INVITATION TO BID

Asphalt Replacement
at
Multiple Properties

ADDENDUM NO. 2

CONTRACT NUMBER: DW2401931

RIVERSTONE

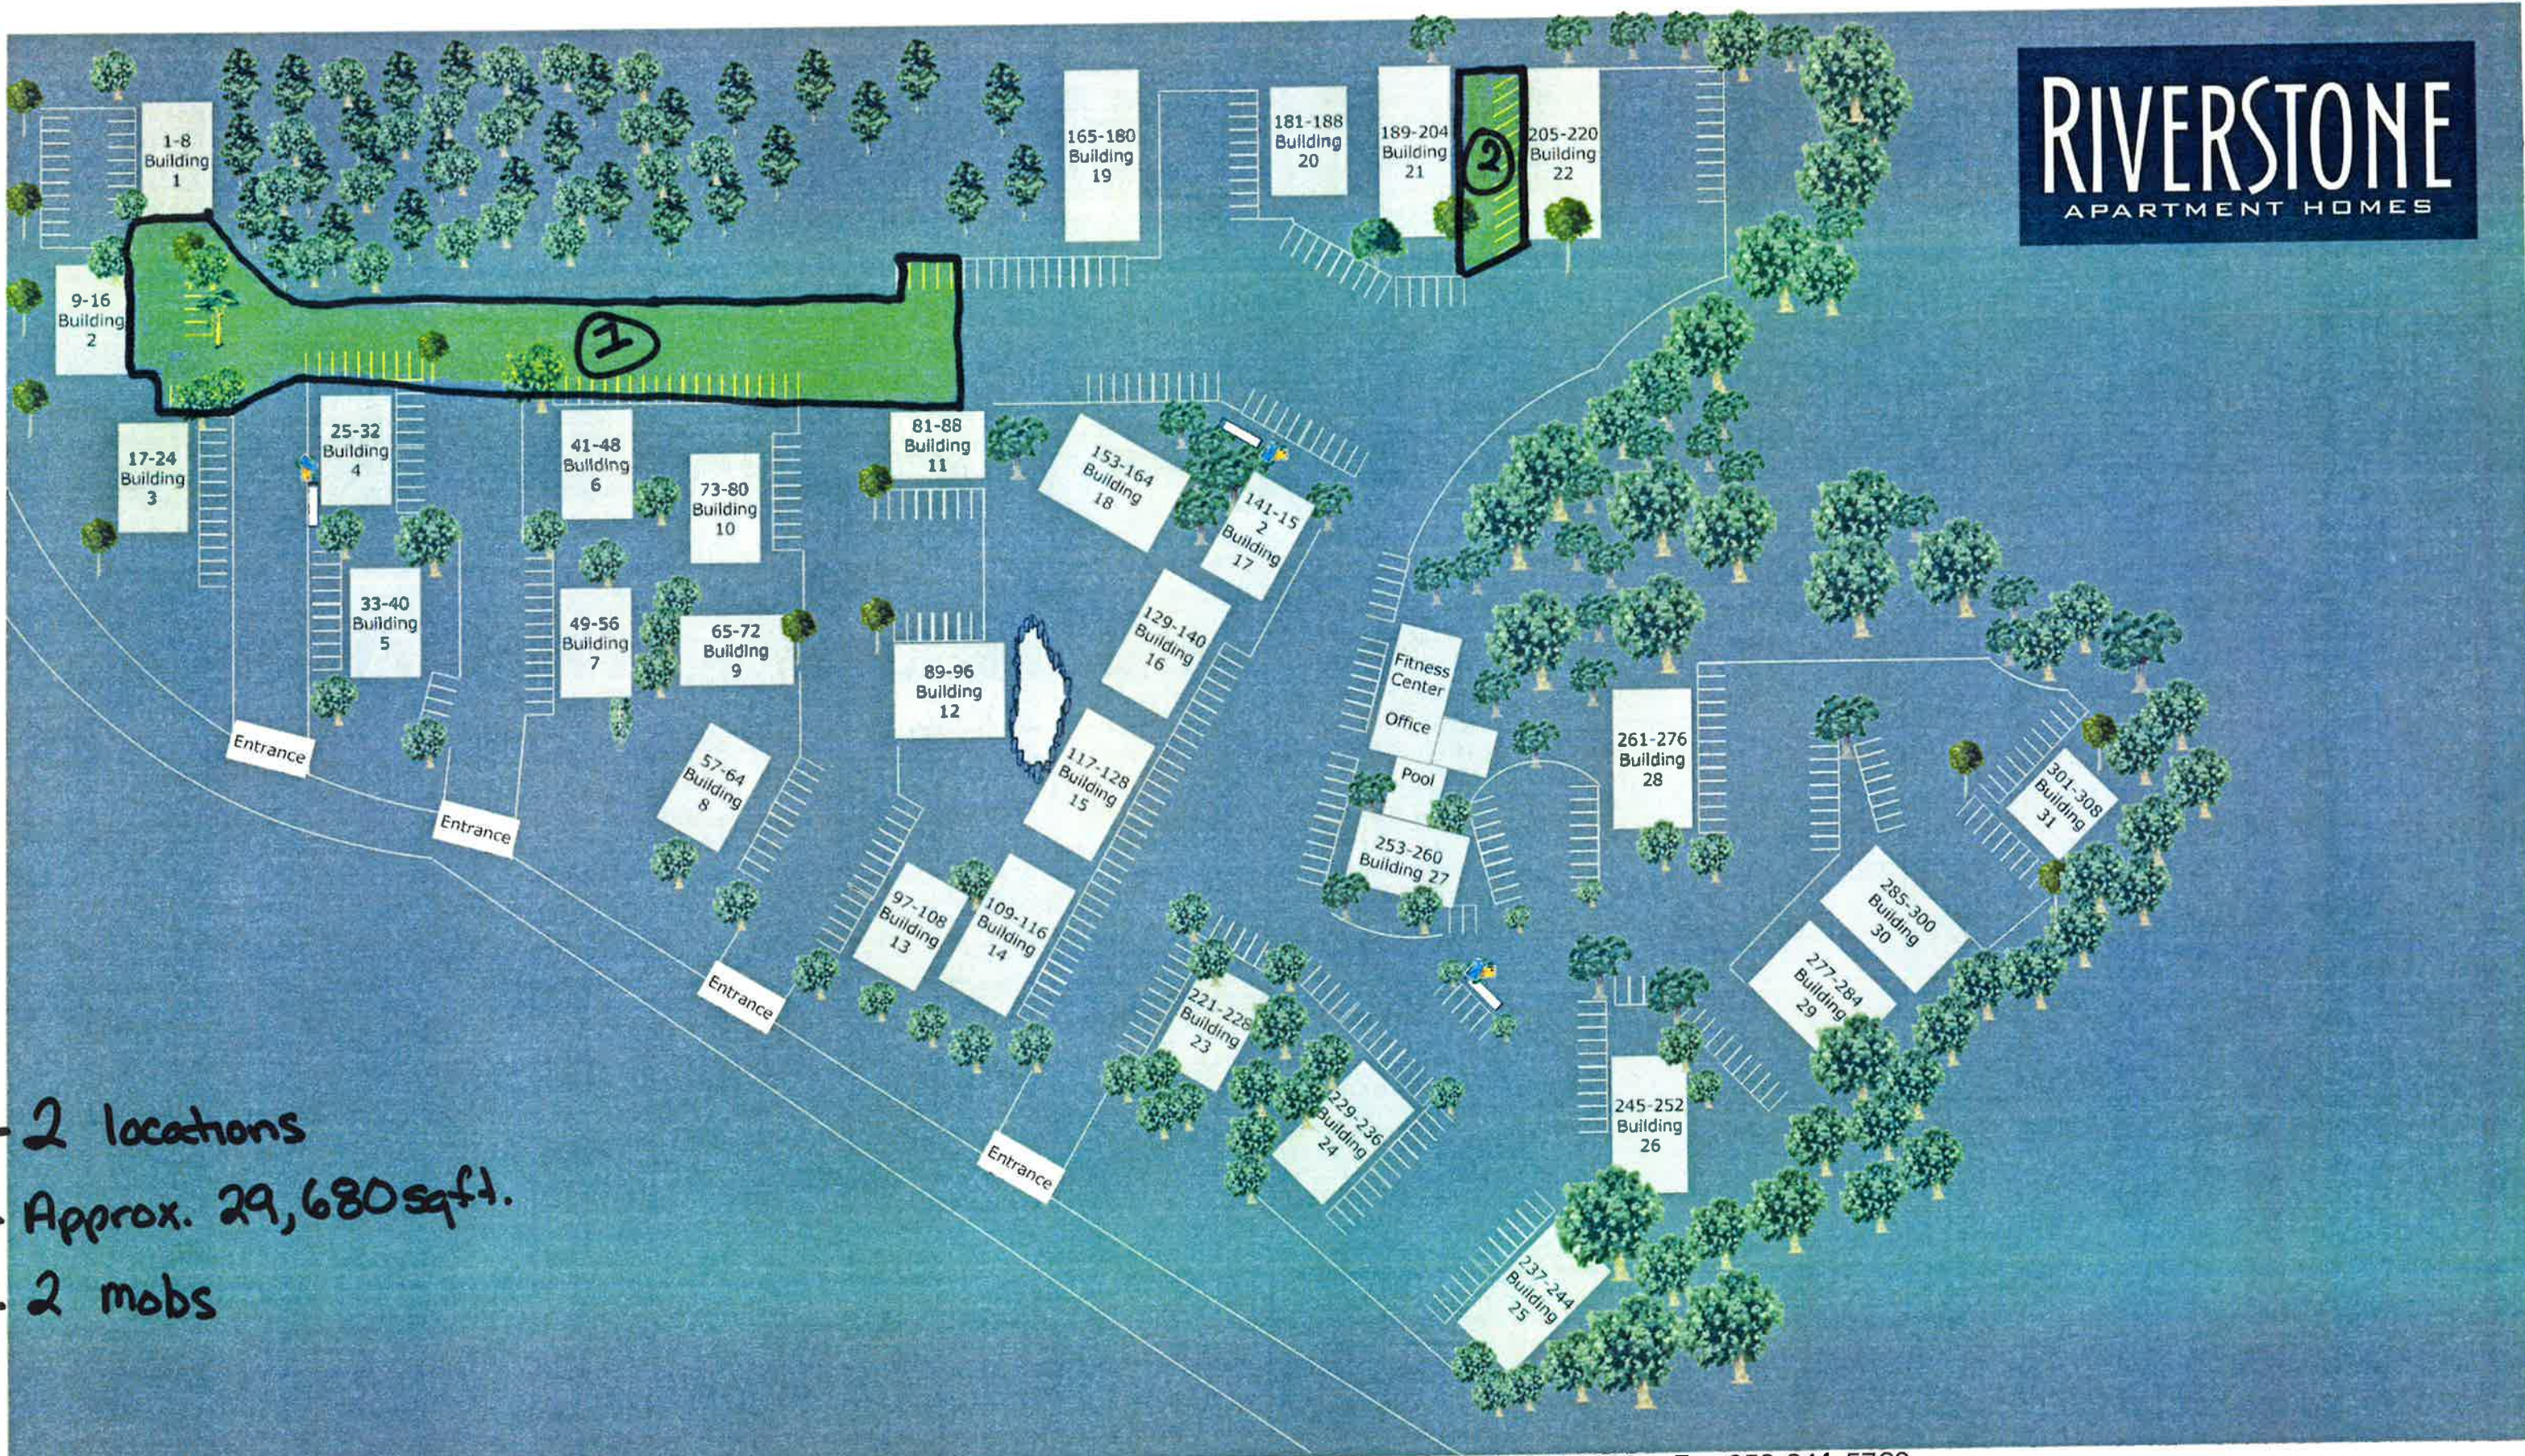
1. Riverstone Apartments: New Map; Same square footage, different locations; No vertical curb work.
2. Specifications section 1.6 D3 reduced from 240 to 200 linear feet of vertical curb.

- 2 locations
- Approx. 29,680 sqft.
- 2 mobs
